ELLIS F. RASKIN
SENIOR COUNSEL
DIRECT DIAL (415) 995-5835
DIRECT FAX (415) 995-3456
E-MAIL eraskin@hansonbridgett.com

January 17, 2023

Re: 28 Walnut Avenue (APN: 073-171-03; Applicant: Bressack and Wasserman Architects)

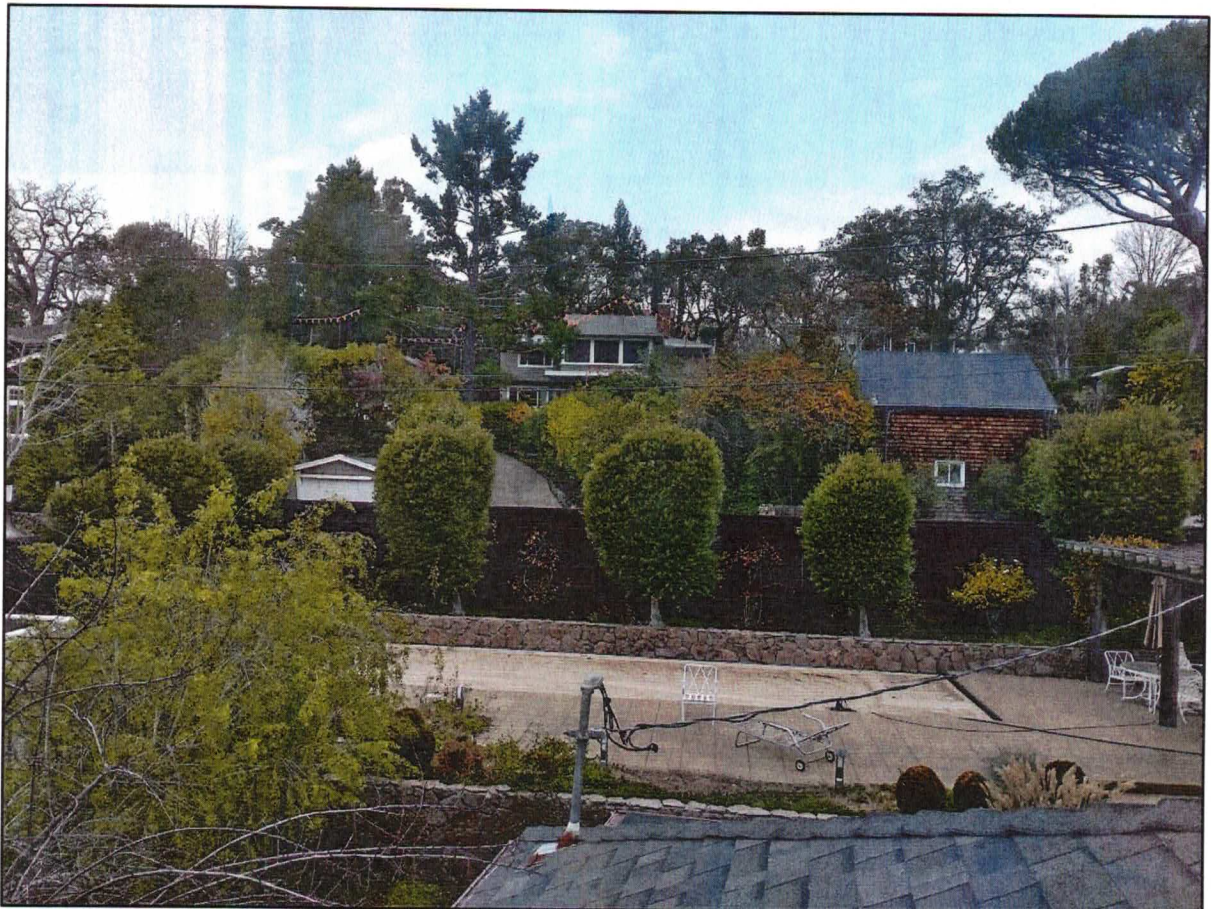
The photo included immediately below demonstrates the current view of 28 Walnut Ave from one of the bedrooms of 15 Walnut Ave. Currently, the primary residence is visible as is the lower garage and the driveway. Of note, the vast majority of the view is dominated by greenery, not structures. The Project at 28 Walnut Ave. proposes removing the large tree in the center of the view as well as the acacia tree on the left side of the photo. The story poles for the Project at 28 Walnut Ave. are also visible and represent the lines and heights of the proposed structures, demonstrating how significantly the view will change. In summary, what was once predominately a view of greenery will become a view of massive buildings out of character with the neighborhood, with no large trees to soften the view.

Project. Note that the roof line of the main residence is being increased as indicated by the story poles. The other two new proposed structures both will be two stories tall (and as tall as the raised primary residence). The combined structure will stretch nearly the entire width of the property. The proposed Project will adversely affect my client's privacy in most areas of the backyard of 15 Walnut Ave., as well as the kitchen, the dining room, and two of three bedrooms.

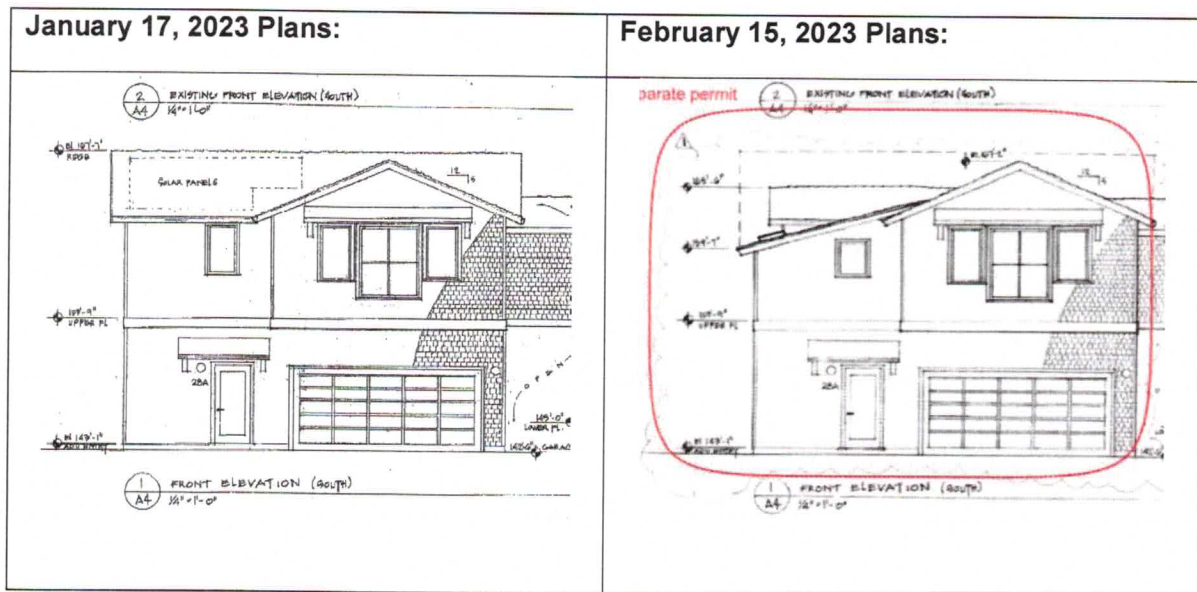
- **Chair Kruttschnitt:**¹ Found that "the ADU should be diminutive to the house and garage, instead it exasperates the mass;" that the " main home seems secondary to the ADU;" and that the "[m]ass should step back with the slope."

- **Member Buckingham:** Noted that the ADU “looks monolithic in scale and almost commercial,” and recommended that the ADU be “stepped back” with a new design that will “push it back into the hillside.”
- **Member Dewar:** Agreed that “the massing of the ADU works against the design of the house and the topography of the site” and that development should be re-focused to the “space behind the garage.”
- **Member Fritz:** Observed that the “ADU has too much mass at the outside of the property” and “[w]ould like to see the ADU in a different location.”

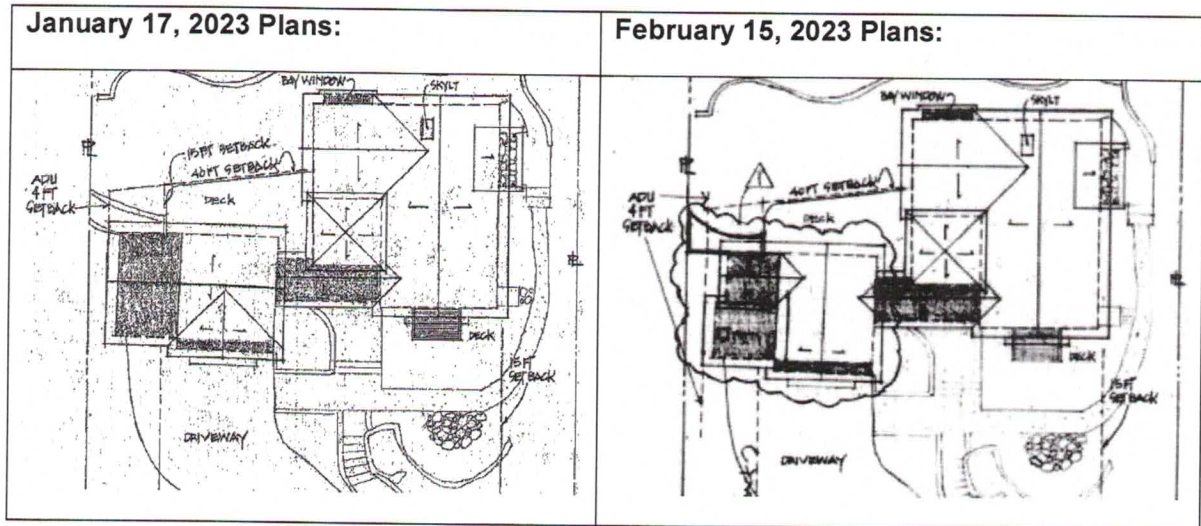
The “revised” plans indicate that the south-facing elevation of the ADU is still the exact same height. When viewed from the public right of way and other surrounding properties, the “revised” design will look identical, with the same bulk and massing. Furthermore, there have been no changes to the placement of the south-facing windows, which still violate design review requirements that forbid locating or designing new structures in a manner that intrudes upon the

privacy of neighbors. (Town Code, § 18.41.100, subd. (m).) As noted in our January 17 letter, these windows peer directly into private areas of adjoining properties.

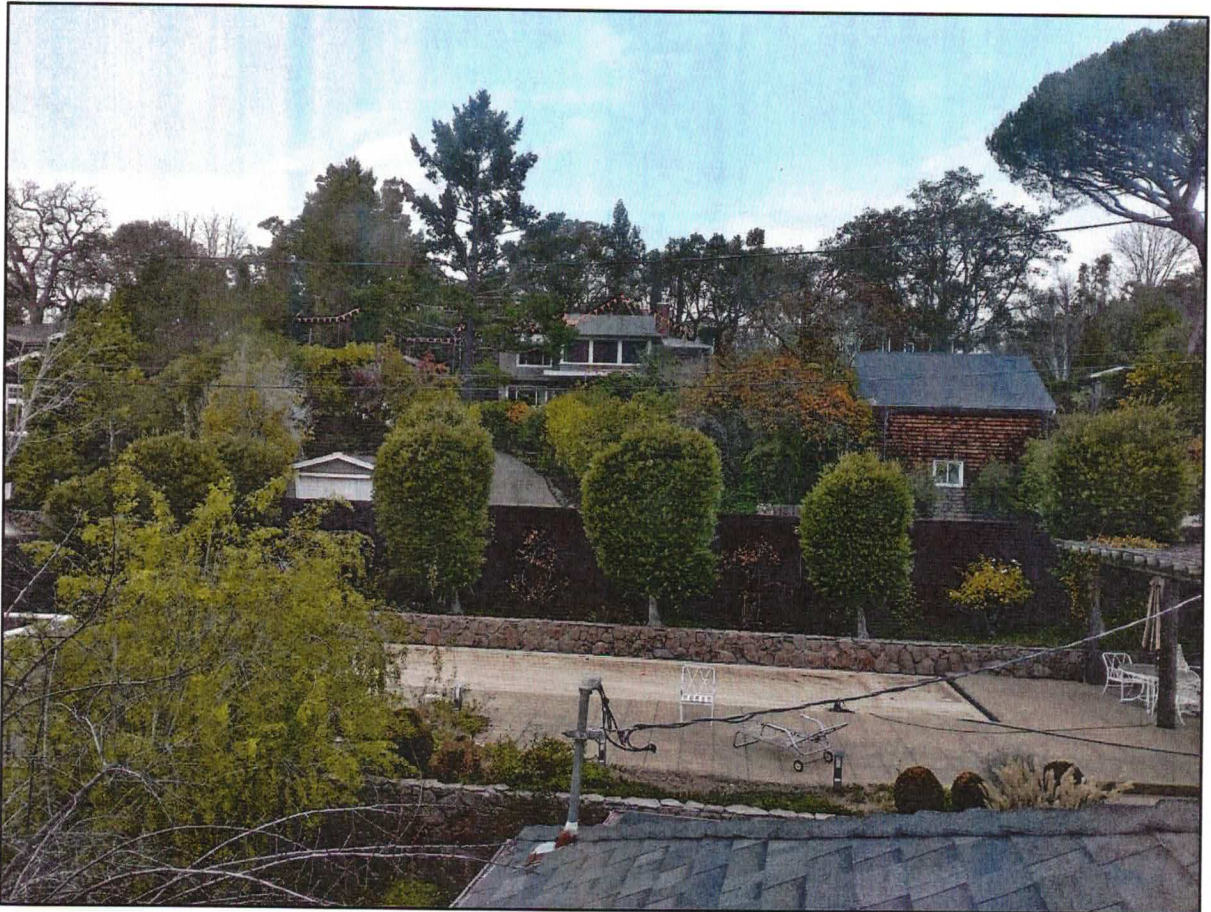
The photo included immediately below demonstrates the current view of 28 Walnut Ave from one of the bedrooms of 15 Walnut Ave. Currently, the primary residence is visible as is the lower garage and the driveway. Of note, the vast majority of the view is dominated by greenery, not structures. The Project at 28 Walnut Ave. proposes removing the large tree in the center of the view as well as the acacia tree on the left side of the photo. The story poles for the Project at 28 Walnut Ave. are also visible and represent the lines and heights of the proposed structures, demonstrating how significantly the view will change. In summary, what was once predominately a view of greenery will become a view of massive buildings out of character with the neighborhood, with no large trees to soften the view.

Project. Note that the roof line of the main residence is being increased as indicated by the story poles. The other two new proposed structures both will be two stories tall (and as tall as the raised primary residence). The combined structure will stretch nearly the entire width of the property. The proposed Project will adversely affect my client's privacy in most areas of the backyard of 15 Walnut Ave., as well as the kitchen, the dining room, and two of three bedrooms.

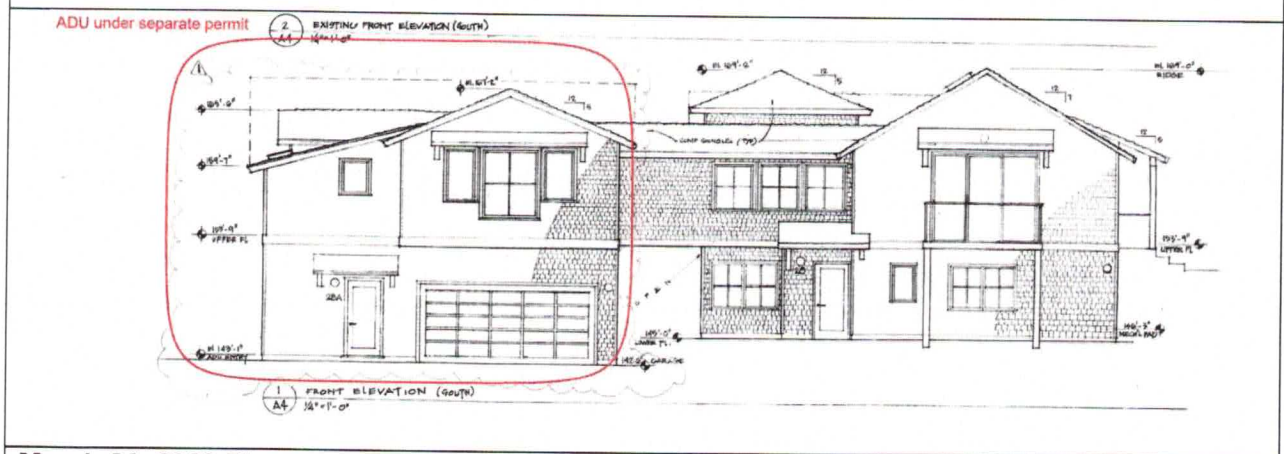
We are disappointed to see that the Project applicants have, for the most part, ignored the Advisory Design Review Group's recommendations (for the second time). As you know, when this Project was first presented to this Group on January 17, this Group unanimously agreed that the Project was monumental, excessively large, and out of character with its setting and with other dwellings in the neighborhood. (See Town Code, § 18.41.100, subd. (c)(1).) Despite these findings, the Project applicants returned on February 15 with a substantially identical design. Unsurprisingly, members of this Group made the following comments:¹

- **Member Dewar:** Noted that it "[d]oes not fee[l] that the comments were heard that the applicant found a work around instead;" and the bridge "increases bulk and mass"
- **Member Buckingham:** Stated that she was "[d]isappointed in the size of the ADU" and also opined that she was "[a]gainst the bridge, [and] thinks the buildings would be better separated which would provide more breathing room."
- **Chair Kruttschnitt:** Found that the "[m]ass is still too large" and "d[id] not like the bridge."

- **Member Fritts:** Found that the “[m]ass of the project is too large;” also “[a]gree[d] with the comments about the deck” and “[a]gree[d] on the bridge, adds to bulk and mass.”
- **Member Sutro:** Indicated his intent to defer to other members of the Group with respect to their comments about the bridge and the Project’s massing.

March 21, 2023 Plans:

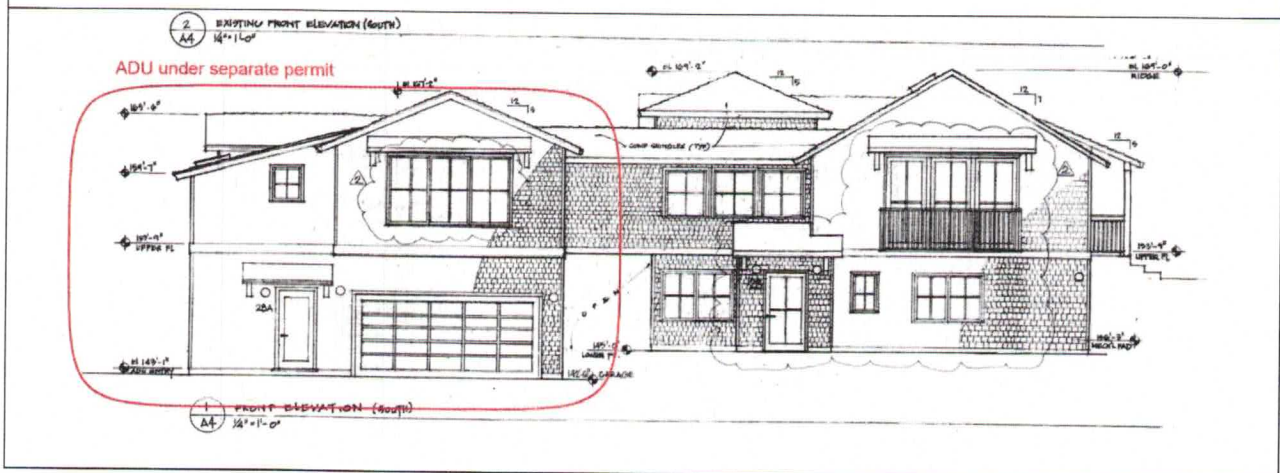
The plans before you tonight are substantially identical to the plans that were submitted on January 17 and February 15, and they do not respond to this Group’s comments regarding the Project’s mass and its consistency with applicable development standards. (See Ross Town Code, Title 18.) In particular, the Project applicants have not addressed the issues presented by the scale and location of the bridge:

The “revised” plans indicate that the Project’s south-facing elevation will still have the exact same height and design. When viewed from the public right of way and other surrounding properties, the “revised” design will look identical, with the same bulk and massing. The Project

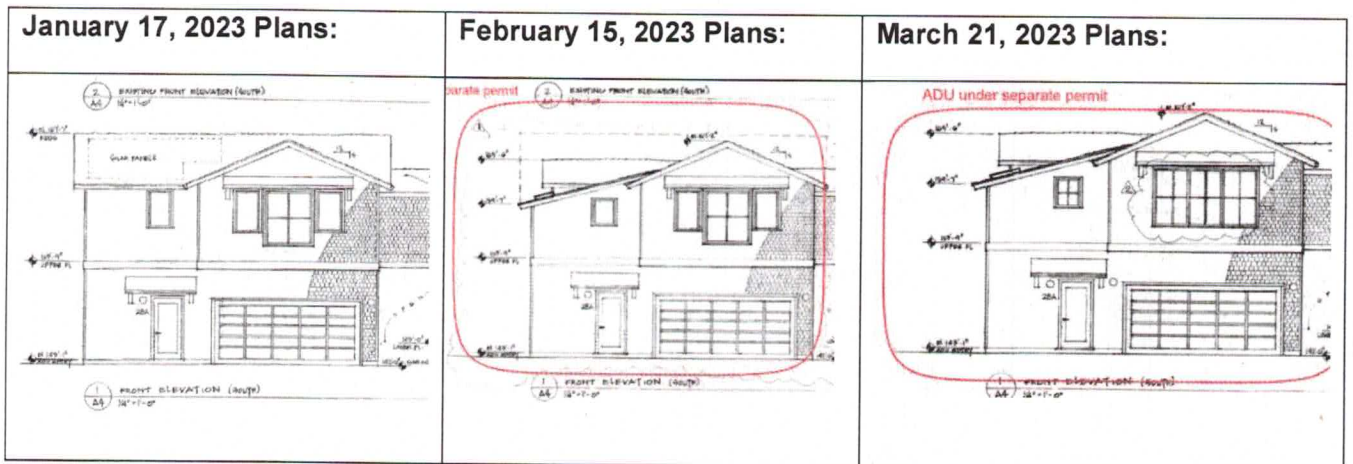
Furthermore, there have been no meaningful changes to the placement of the south-facing windows, which still violate design review requirements that forbid locating or designing new structures in a manner that intrudes upon the privacy of neighbors. (Town Code, § 18.41.100, subd. (m).) As noted in our January 17 and February 15 letters, these windows peer directly into private areas of adjoining properties. In fact, the windows in the ADU now appear to be even bigger:

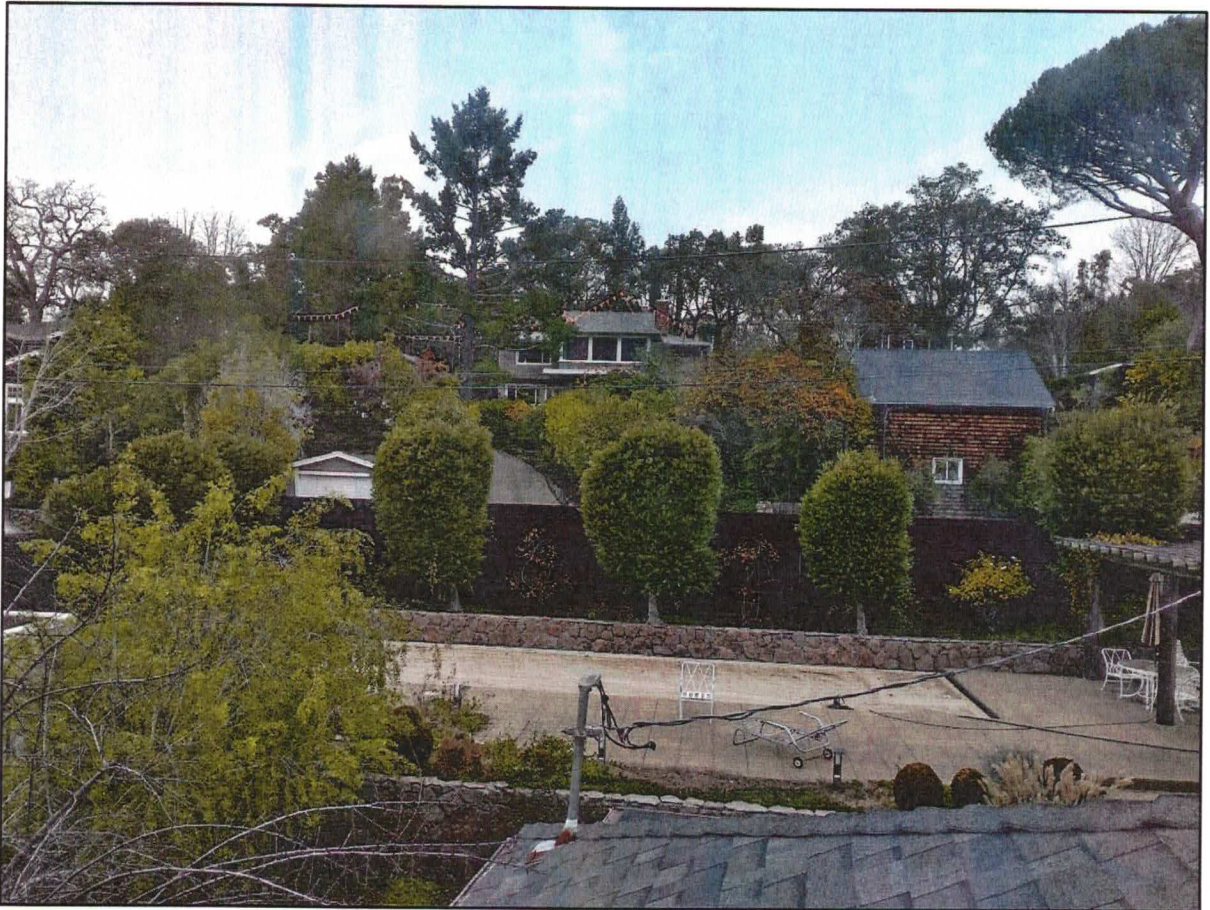
The photo included immediately below demonstrates the current view of 28 Walnut Ave from one of the bedrooms of 15 Walnut Ave. Currently, the primary residence is visible as is the lower garage and the driveway. Of note, the vast majority of the view is dominated by greenery, not structures. The Project at 28 Walnut Ave. proposes removing the large tree in the center of the view as well as the acacia tree on the left side of the photo. The story poles for the Project at 28 Walnut Ave. are also visible and represent the lines and heights of the proposed structures, demonstrating how significantly the view will change. In summary, what was once predominately a view of greenery will become a view of massive buildings out of character with the neighborhood, with no large trees to soften the view.

Project. Note that the roof line of the main residence is being increased as indicated by the story poles. The other two new proposed structures both will be two stories tall (and as tall as the raised primary residence). The combined structure will stretch nearly the entire width of the property. The proposed Project will adversely affect my client's privacy in most areas of the backyard of 15 Walnut Ave., as well as the kitchen, the dining room, and two of three bedrooms.

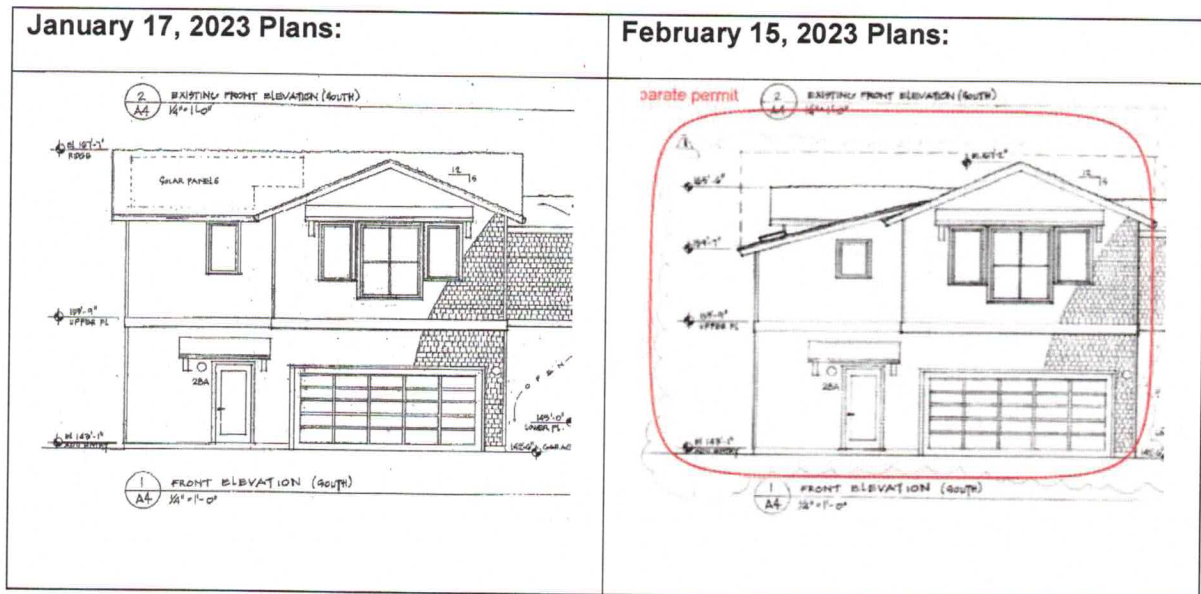
- **Chair Kruttschnitt:**¹ Found that "the ADU should be diminutive to the house and garage, instead it exasperates the mass;" that the "main home seems secondary to the ADU;" and that the "[m]ass should step back with the slope."

- **Member Buckingham:** Noted that the ADU “looks monolithic in scale and almost commercial,” and recommended that the ADU be “stepped back” with a new design that will “push it back into the hillside.”
- **Member Dewar:** Agreed that “the massing of the ADU works against the design of the house and the topography of the site” and that development should be re-focused to the “space behind the garage.”
- **Member Fritz:** Observed that the “ADU has too much mass at the outside of the property” and “[w]ould like to see the ADU in a different location.”

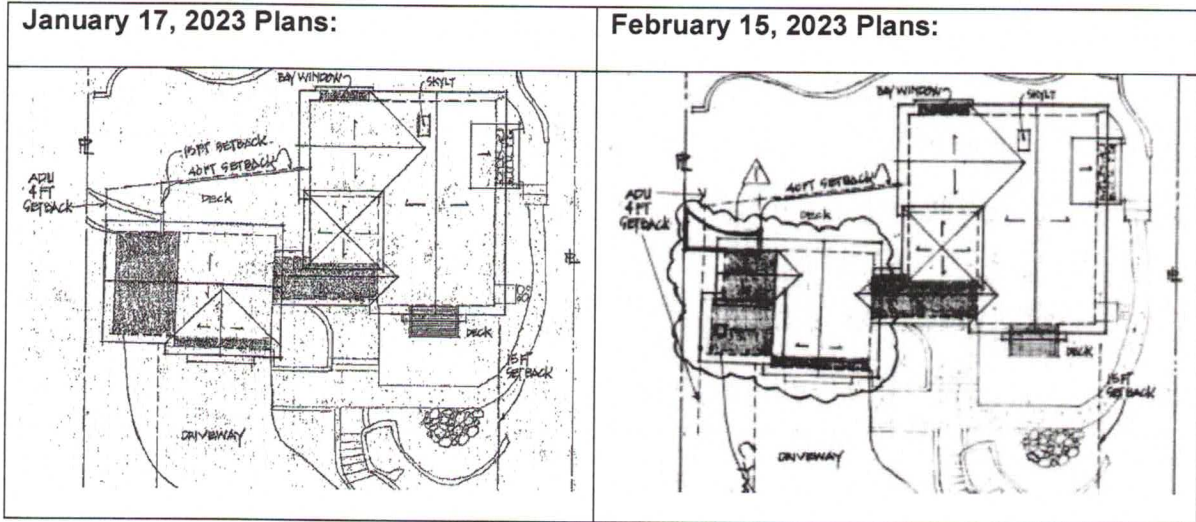
The “revised” plans indicate that the south-facing elevation of the ADU is still the exact same height. When viewed from the public right of way and other surrounding properties, the “revised” design will look identical, with the same bulk and massing. Furthermore, there have been no changes to the placement of the south-facing windows, which still violate design review requirements that forbid locating or designing new structures in a manner that intrudes upon the

privacy of neighbors. (Town Code, § 18.41.100, subd. (m).) As noted in our January 17 letter, these windows peer directly into private areas of adjoining properties.
